EVMK2HX Known Issues

2.1 EMAC Link Down Issue

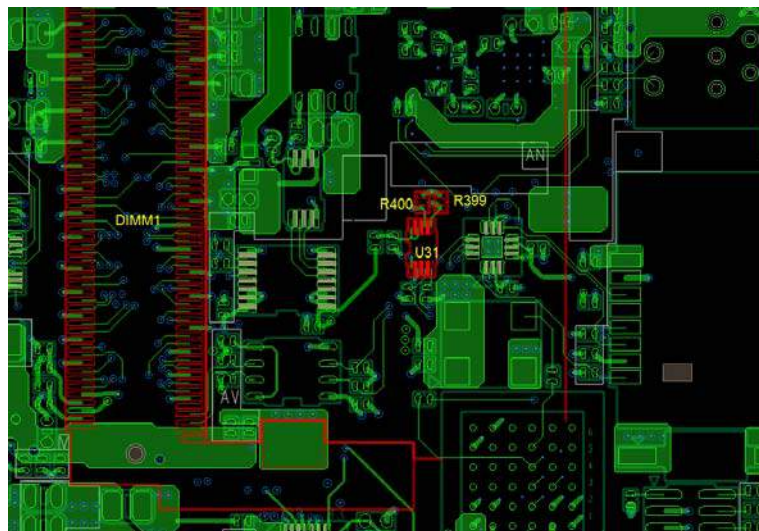
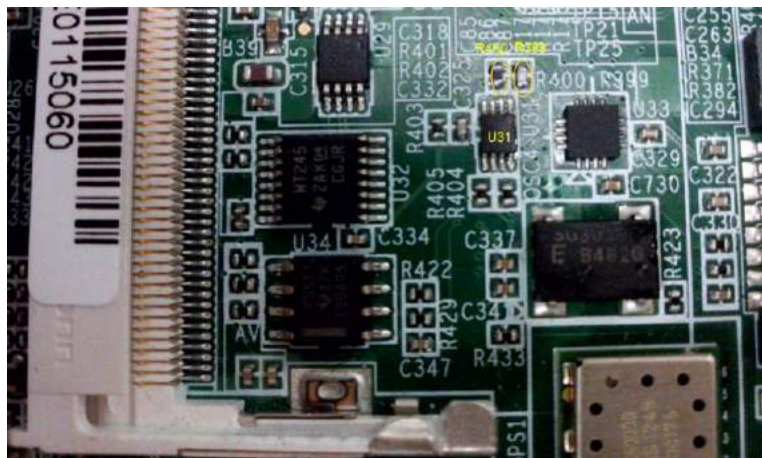
- Description: Noise on MDCLK signal impacts stability of the MDIO link. When Linux kernel sees MDIO link go down it tears down data link as well. Have not seen an issue with using MDIO link to configure external PHY.
- Workaround: Different options under investigation.
 1. Modify code not to depend upon MDIO link remaining active for EMAC communication
 2. Add stronger pull-up resistors on MDCLK and MDIO signal, by replacing R399/R400 from 4.7 kohm with 220 ohm resistors (0402 sized)

- Plans for a fix: Will clean up routing of MDCLK signal on Rev2.0. BOM will also be changed on future builds to incorporate 220ohm resistor pull-up changes.

2.2 VCC0V85 Voltage Drop Issue

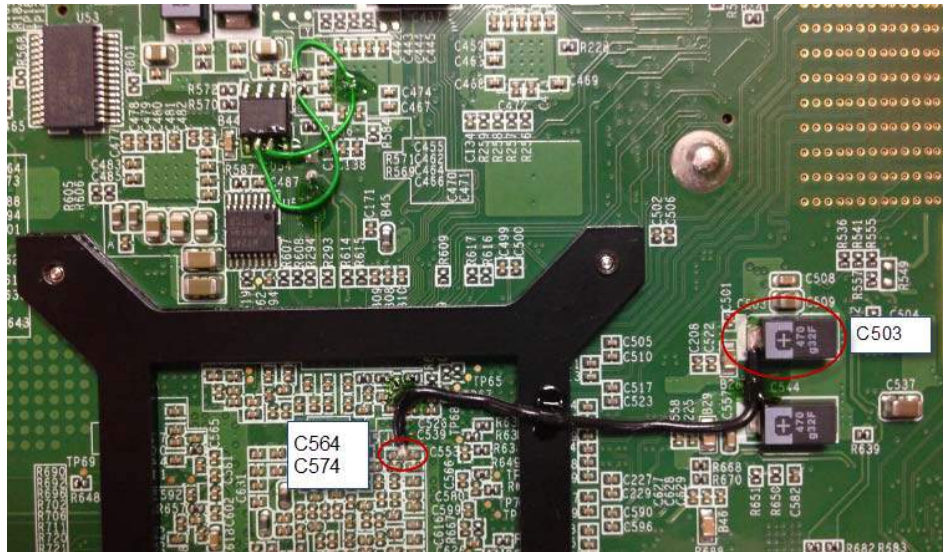
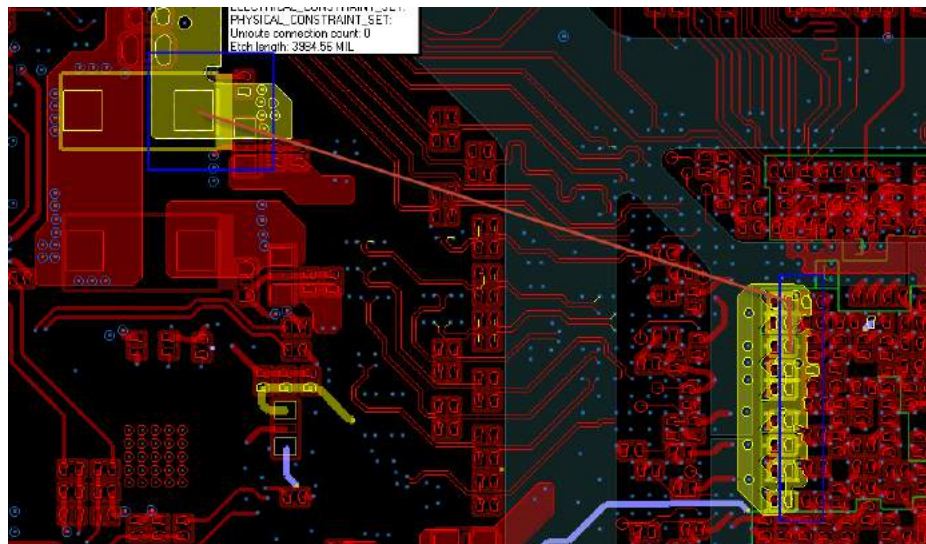
- **Description:** The trace width of the VCC085 signal is too narrow and causes a voltage drop at the pin of the SOC. Since this supply is used for SerDes interfaces it could cause SerDes interfaces to lose link. This issue has only been identified and observed on the SGMII.
- **Workaround:** A couple different options are still under investigation for their effectiveness.
 1. Add external wire to provided adequate patch for expected current from pin 1 of “C503” (net VCC0V85) to pin 1 of “C564, C574” (net VDD0V85). (Wire length = 5 cm)

Note: That the rework should not link to GND and cause short circuit.

- Plans for a fix: The trace width will be fixed on Rev2.0. The filter element on AVDDALV requires an increased current capacity (suggest up to 4A) to allow for margin on worse-case power as per latest Snowbush power estimates when all SERDES are active. Increase of current capacity on filtering elements for AVDDAHV also recommended (suggest up to 3A). Please see latest estimates below. CVDD power budgeted already on the DSP AVS supply. Both of these nets shall be implemented as copper pours up to the filters and as a plane afterwards to minimize resistance and inductance and maximize plane capacitance.

2.3 I2C SDA/SCL Reserve Issue

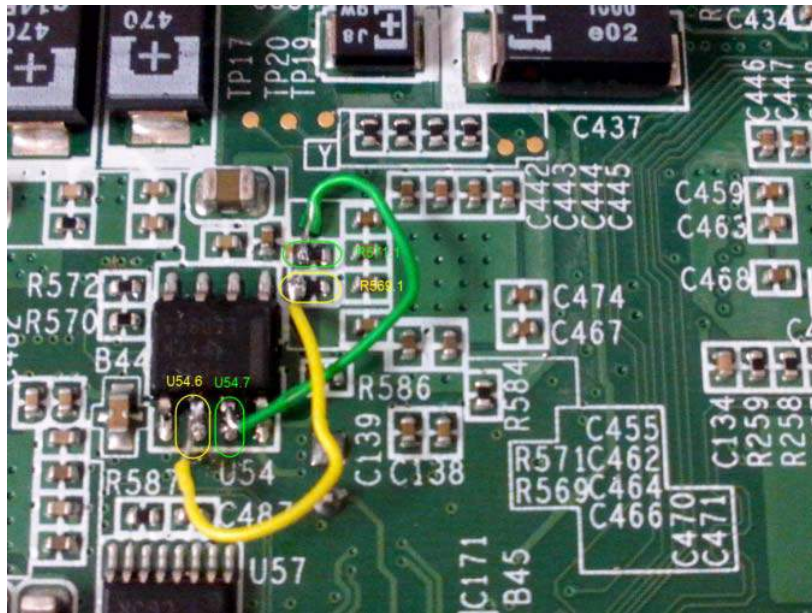
- Description: SCL and SDA are swapped on U54 bus repeater. Impacts I2C going to 120p Expansion Connector and Zone 3 RTM connector.
- Workaround: Cut the jumper wire (30AWG) to swapped signal of EXP_SDA2_3V3 and EXP_SCL_3V3. Two wire each to similar yellow and green to link from U54.6 to R569.1 and U54.7 to R571.1 .

- Plans for a fix: This will be corrected on Rev2.0.

3.2 VCC0V85 Voltage Drop Issue

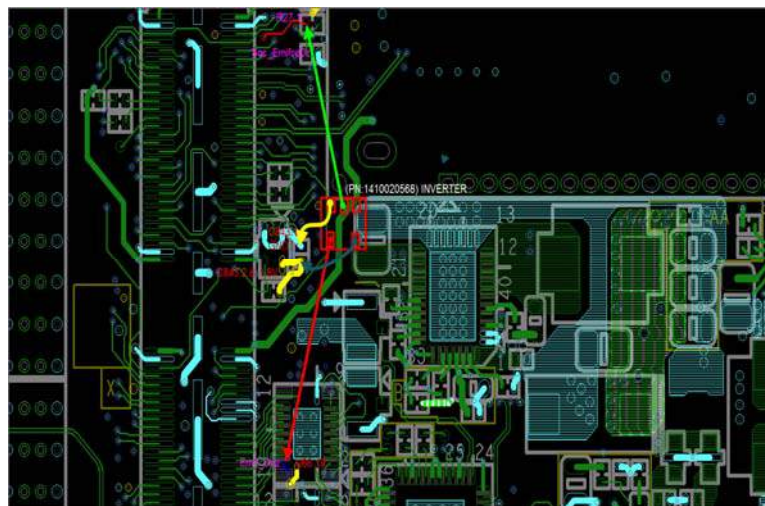
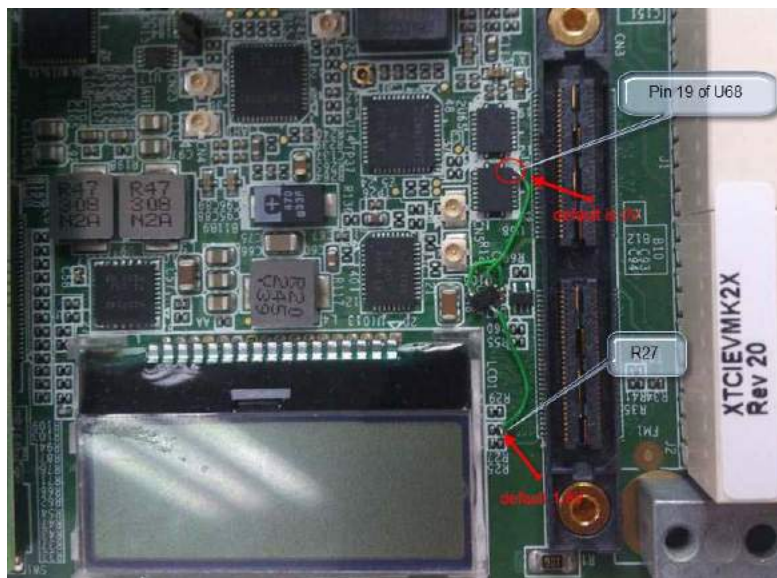
- Workaround: An external wire is added to provided adequate patch for expected current from pin 1 of “C503” (net VCC0V85) to pin 1 “C564, C574” (net VDD0V85). (Wire length = 5 cm). Also, the wire is glued on heat sink back plate for stability.

4.2 USB Device Not Work

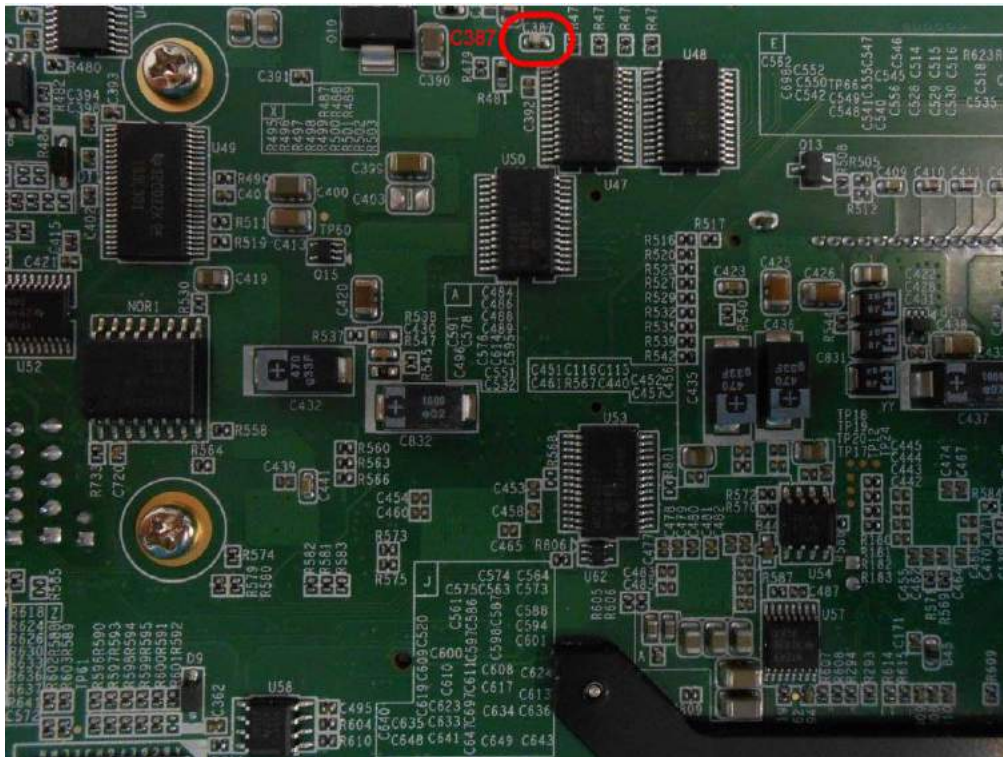
- **Description:** USB 3.0 port could not work even Linux kernel loaded. The cause is 5V rail turned off due to overshoot/undershoot protection.
- **Workaround:** A couple different options are still under investigation for their effectiveness.
 1. Increase 5V overshoot/undershoot margin in with UCD9090 XML File (UCD9090_104_A04.XML) in TI Fusion Power Manager Tool so 5V rail would not be turned off.
 2. Remove C387 (56pf) extra capacitor on 5V rail to solve overshoot/undershoot symptom. (The solution will be applied from Rev 3.0 EVM and later revisions.)

- **Plans for a fix:** C387 will be removed from Rev 3.0 EVM. User who has Rev 2.0 EVM could choose to remove C387 or apply updated xml file to solve the symptom.

4.3 SoC PWR stop on Power-up

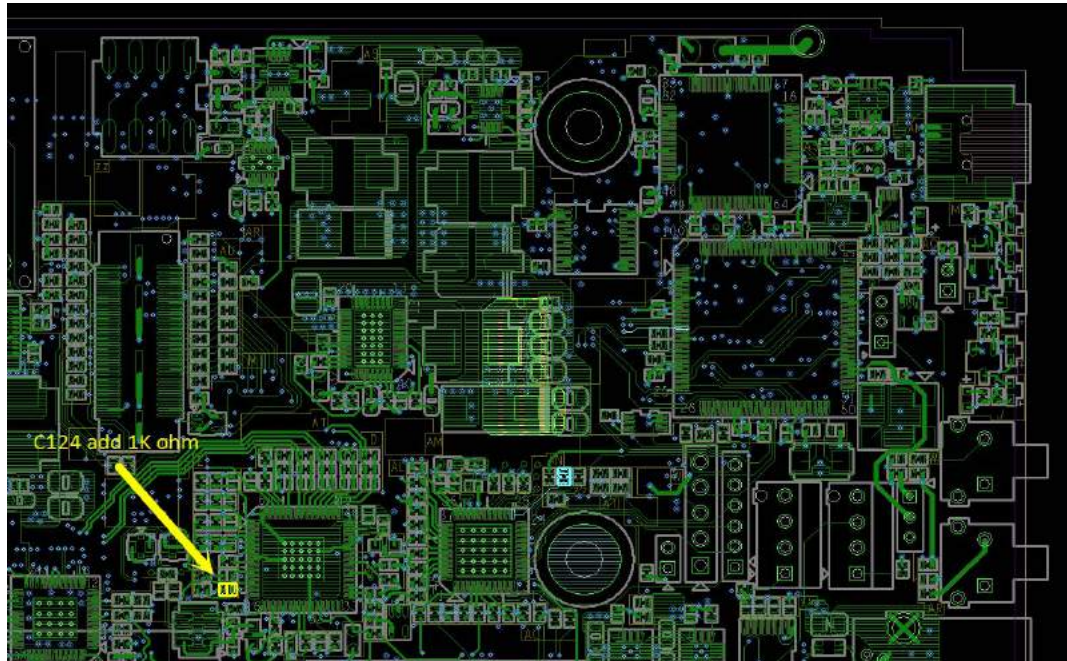
- Description: UCD controller detects a fault during power-on and aborts the power-on sequence.
- Workaround: The fault comes from un-used CVDDT rail and FLT pin is floating. Adding a 1K ohm resistor on location C124 will pull-down the un-used FLT pin and avoid false fault signal.

- Plans for a fix: The 1Kohm resistor is added before Rev 2.0 EVM shipping.

4.4 Warning Messages in TFTP test on NAND Flash

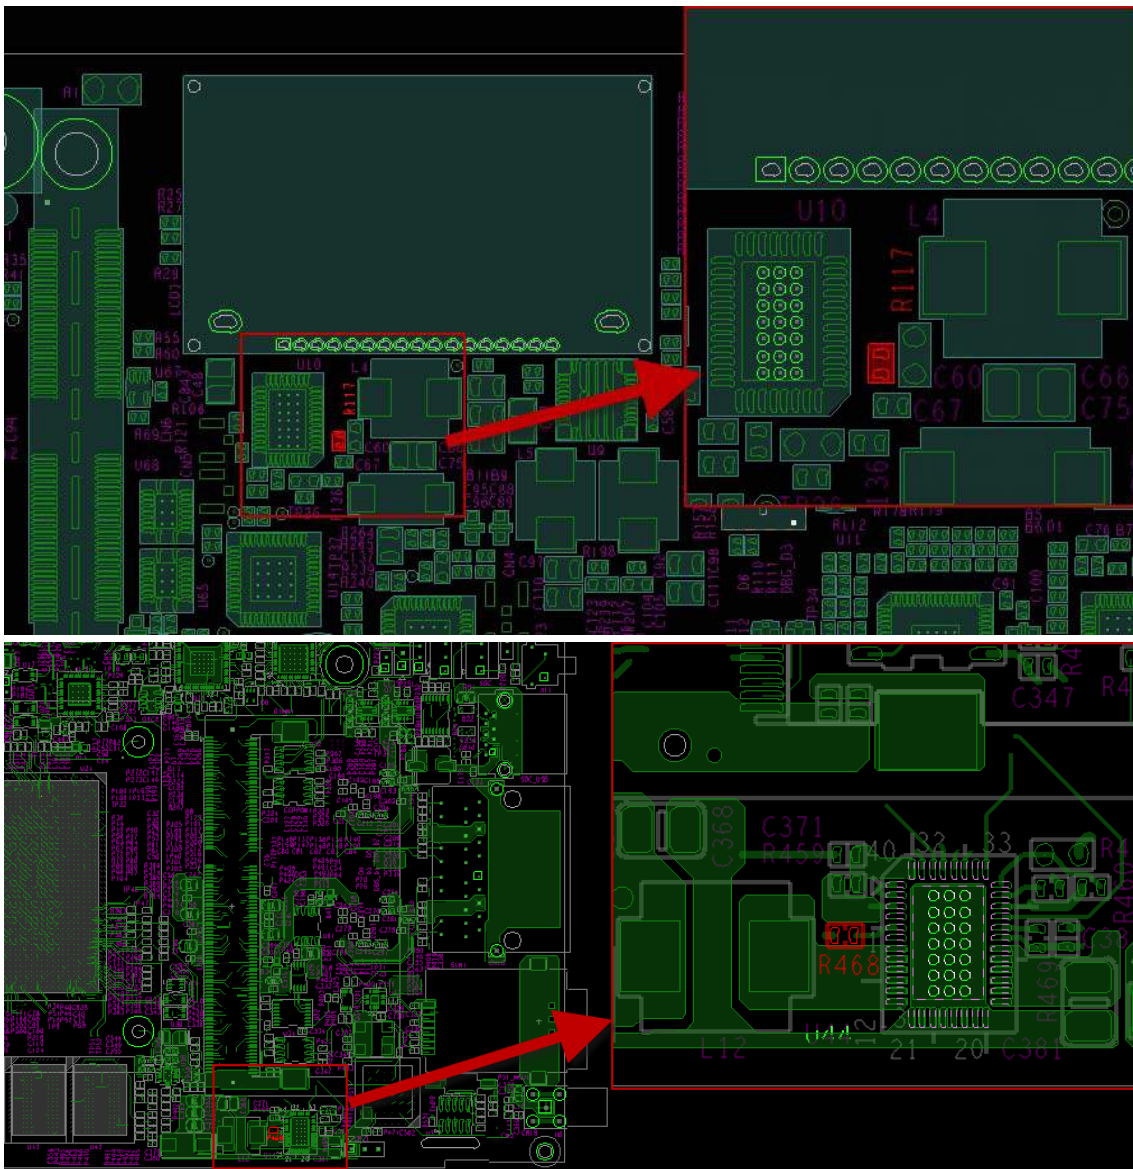
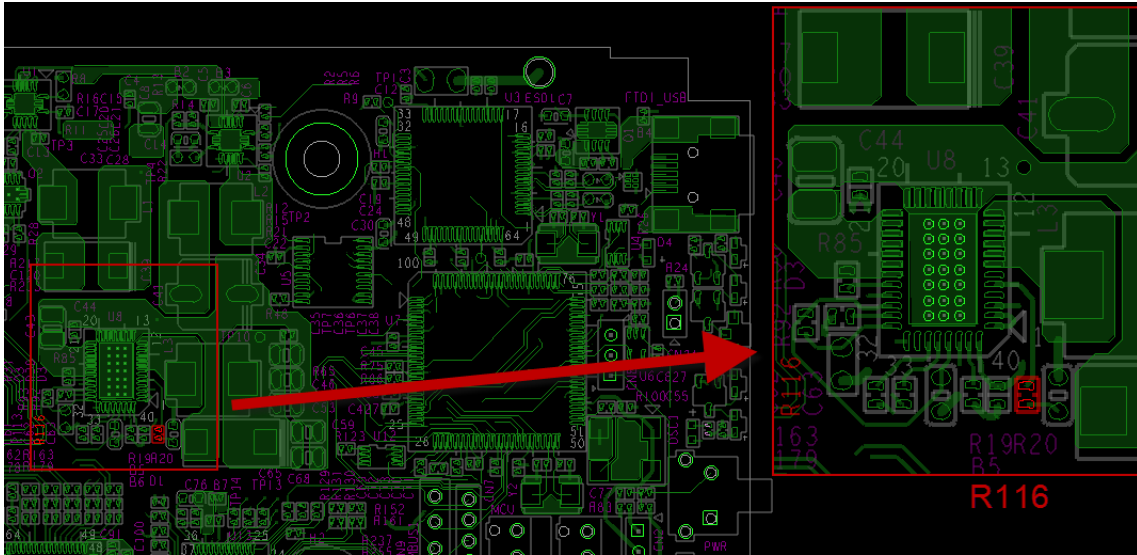
- **Description:** When performing TFTP test on NAND in Linux, there are warning messages frequently. The symptom is related to power phase noise coupling on EMIF signals. Increasing boot resistor value could mitigate the issue but won't solve the issue completely.
- **Workaround:**
 1. Change R117 from 0 ohm to 10 ohm (boot resistor for CVDD/U10/UCD74120)
 2. Change R468 from 0 ohm to 10 ohm (boot resistor for CVDD/U44/UCD74120)
 3. Change R116 from 0 ohm to 10 ohm (boot resistor for VCC1V5/U8/UCD74111)

- Plans for a fix: This issue is found in Rev 3.0 and it will also affect Rev 2.0 EVM. The resistor value change will be installed on all Rev 3.1 board before shipping. Root causes are still under investigation.

5.3 Power up will happen SoC PWR stop

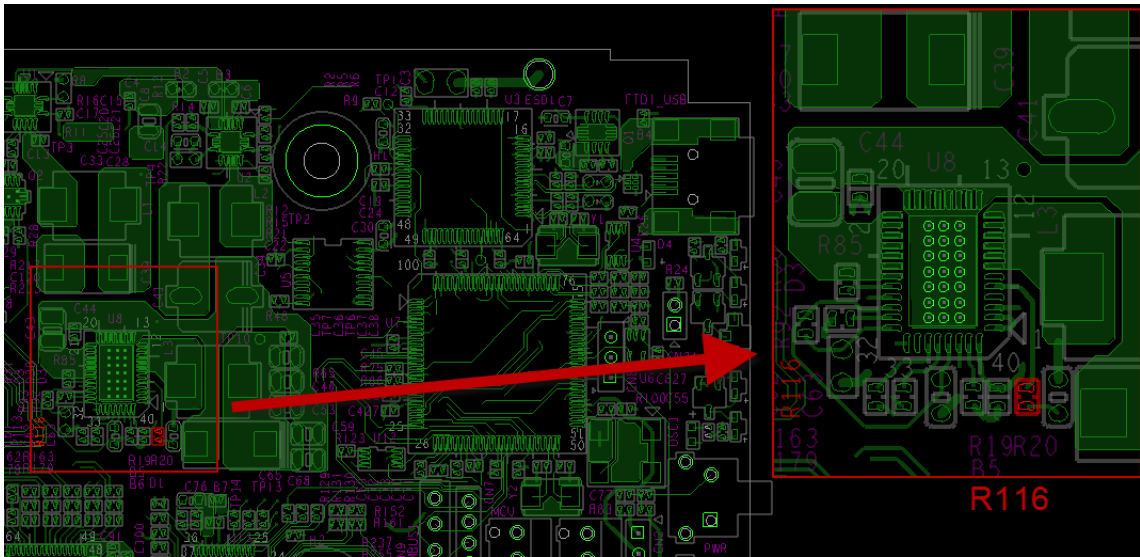
- Workaround: Add a 1K ohm resistor on to GND.

6.1 Warning Messages in TFTP test on NAND Flash

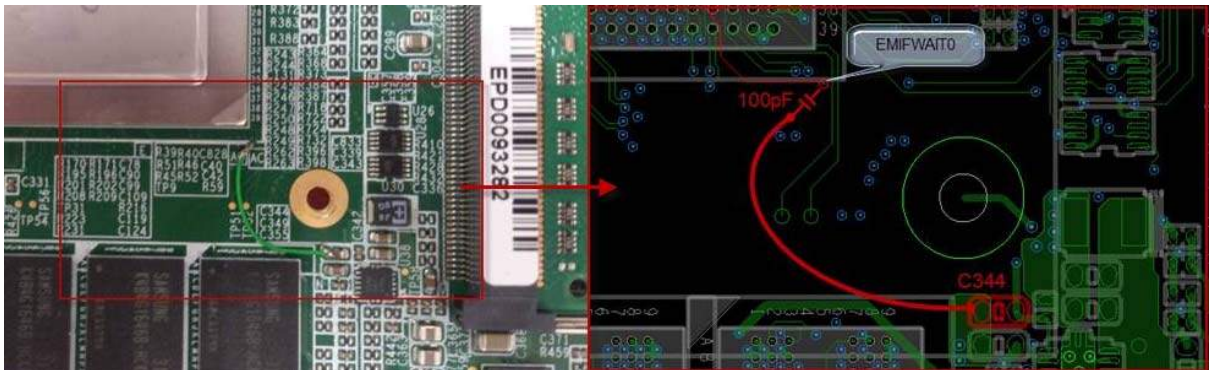
- Description: When performing TFTP test on NAND in Linux, there are warning messages frequently. The symptom is related to power phase noise coupling on EMIF signals. Increasing boot resistor value could mitigate the issue but won't solve the issue completely. (This is the same issue as 4.4.)
- Workaround:
 1. Change R117 from 0 ohm to 10 ohm (boot resistor for CVDD/U10/UCD74120)
 2. Change R468 from 0 ohm to 10 ohm (boot resistor for CVDD/U44/UCD74120)
 3. Change R116 from 0 ohm to 10 ohm (boot resistor for VCC1V5/U8/UCD74111)

Plans for a fix: The resistor value change will be installed on all Rev 3.1 board before shipping. If there are still NAND warning messages, please perform following rework: “add 100pF on R/B# of EMIF interface close to SoC (on the via of net “EMIFWAIT0”, green print on the via should be removed) and add GND connection to pin1 of C344”.

8.3 USB Device failures

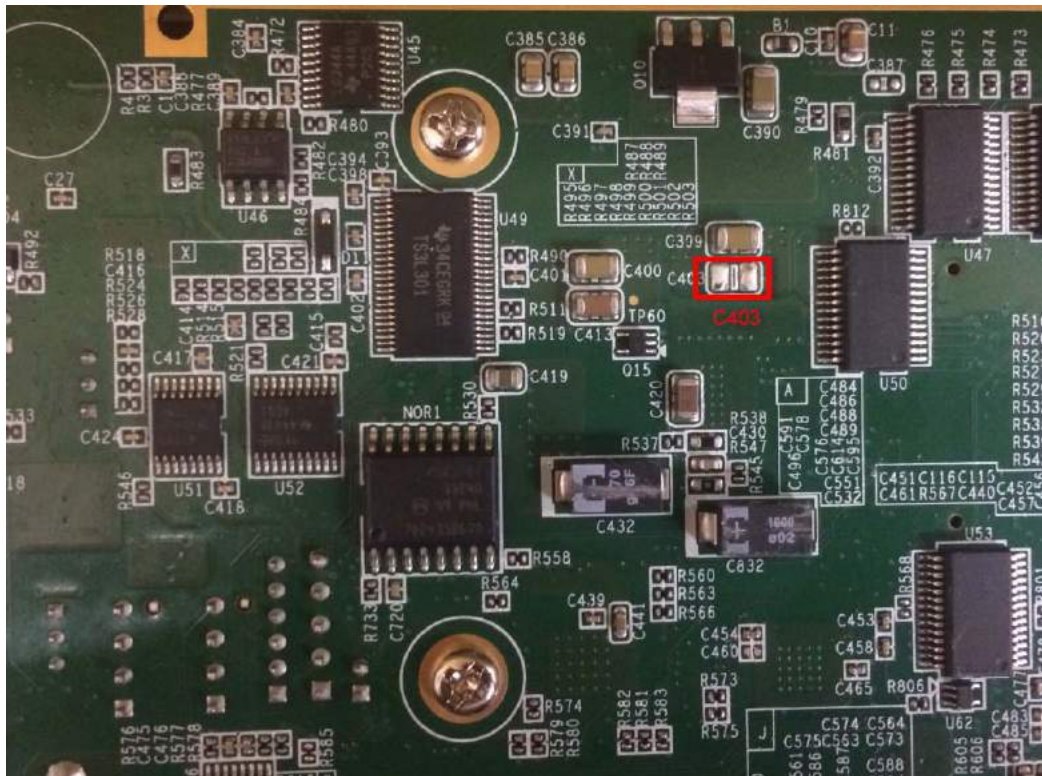
- Description: USB not functional after power-up even after Linux kernel loaded. The cause is power supply instability of the VCC5 supply on some boards. This instability

occurs because the VCC5 supply has no load at startup until after the USB port is enabled in host mode. Once USB is enabled in host mode, the instability is eliminated.

2. The instability can be resolved by adding a small load to the VCC5 supply. You can install a 510 ohm resistor on the NL capacitor location C403. This location is shown in the picture below. Note: this is on the back-side of the board.

- Plans for a fix: C403 will be stuffed with a 510 ohm resistor on all new production units. The UCD9090 configuration loaded will contain the standard 15% limits for overshoot and undershoot.
